NRL Report No. B-1297  
BuEng. Prob. IC-93

Report of Test

Horn, Navy Type A1

E. A. Laboratories,

Plate 2

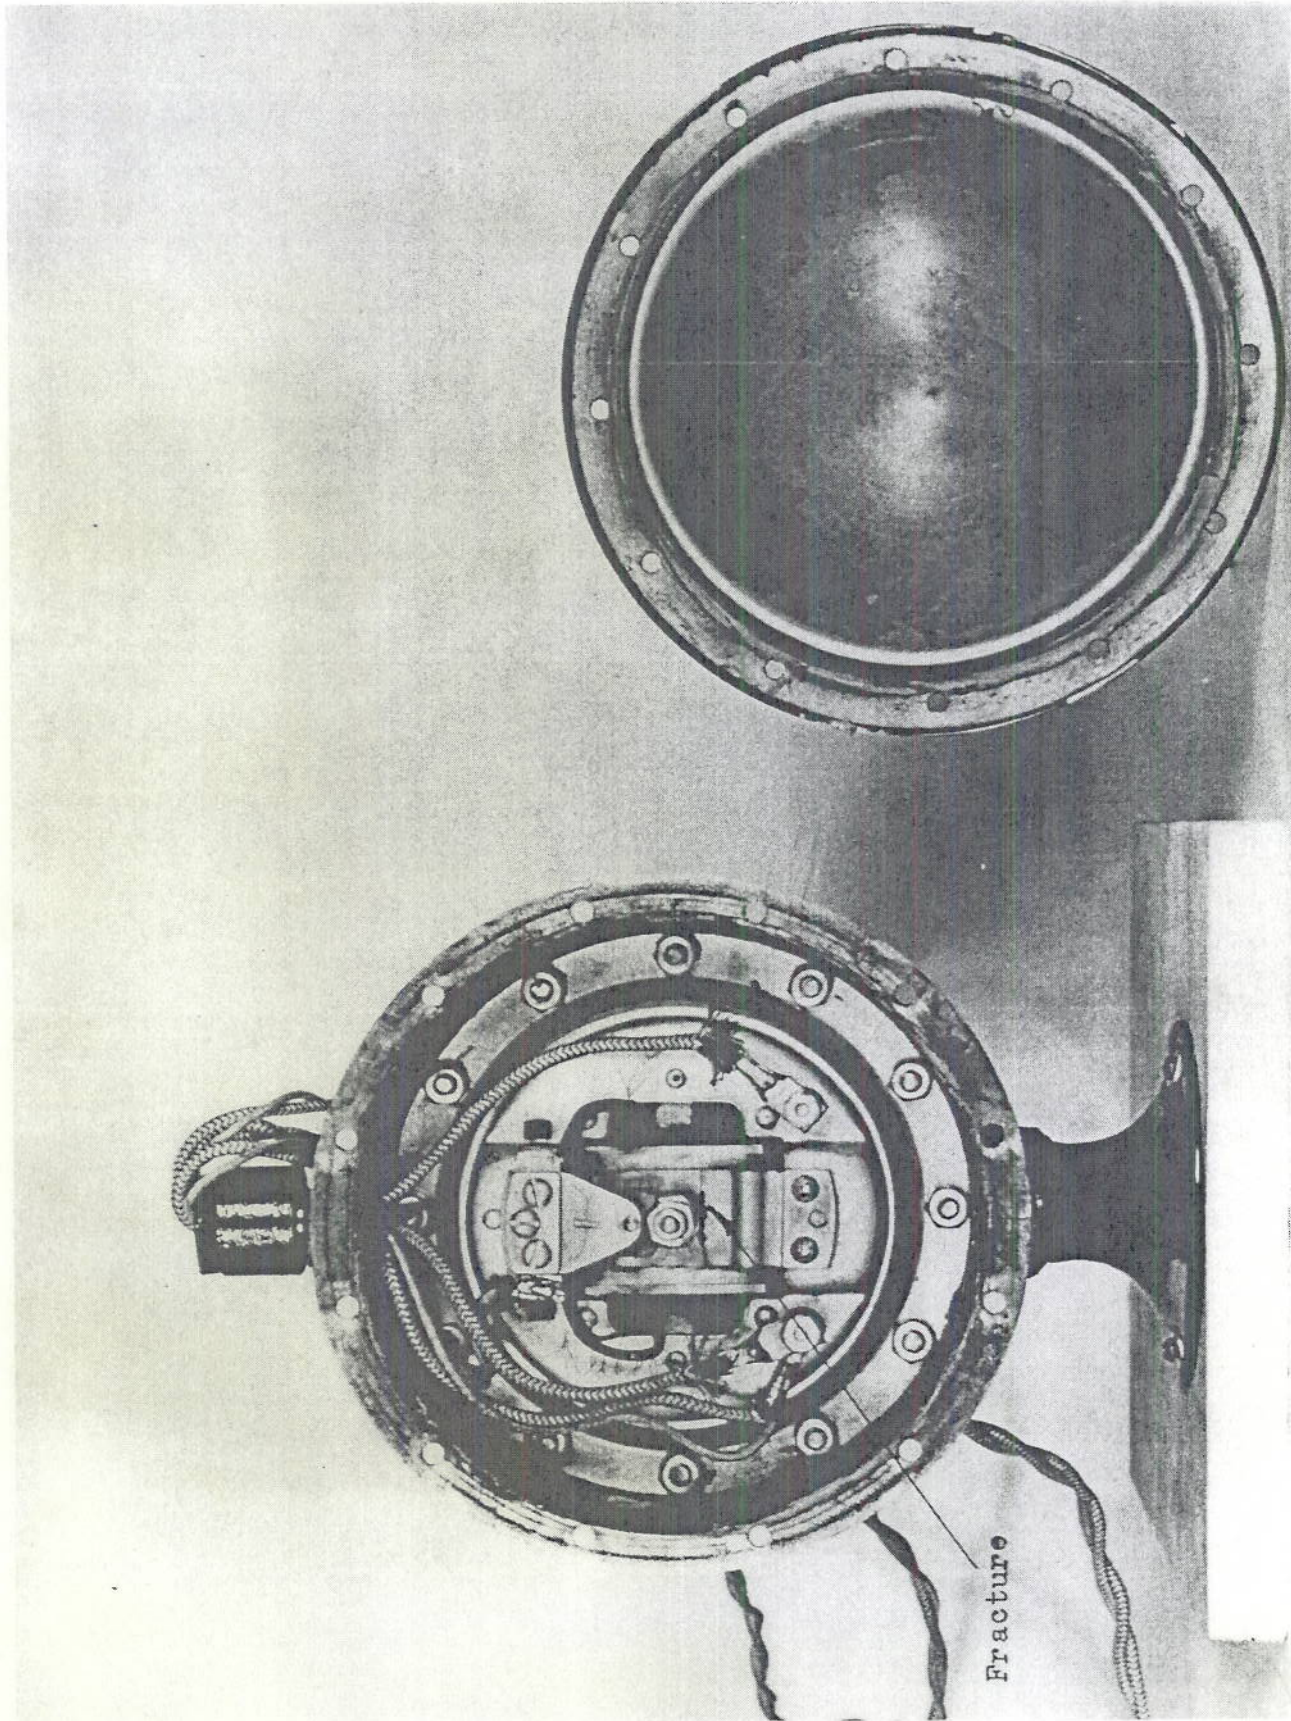
- (1) Under test for endurance, a fracture occurred in the spring supporting the armature. The time at which the fracture occurred is not known in view of the fact there was no indication of trouble during the required 48 hour test. This fracture occurred just below the adjustment nut and is shown by Plate 2.

Fracture

- (2) Experiment with two (2) armature springs substituted for the present single one. Both springs should be of a shape similar to, but longer than that which would be obtained by cutting the present one in half on a line perpendicular to its length. Provision should be made to allow a sliding action where they are secured to the armature. This suggestion is based on the fact that the horn operated satisfactorily after one half of the spring had become ineffective due to fracture, indicating that not all of the spring tension was necessary.
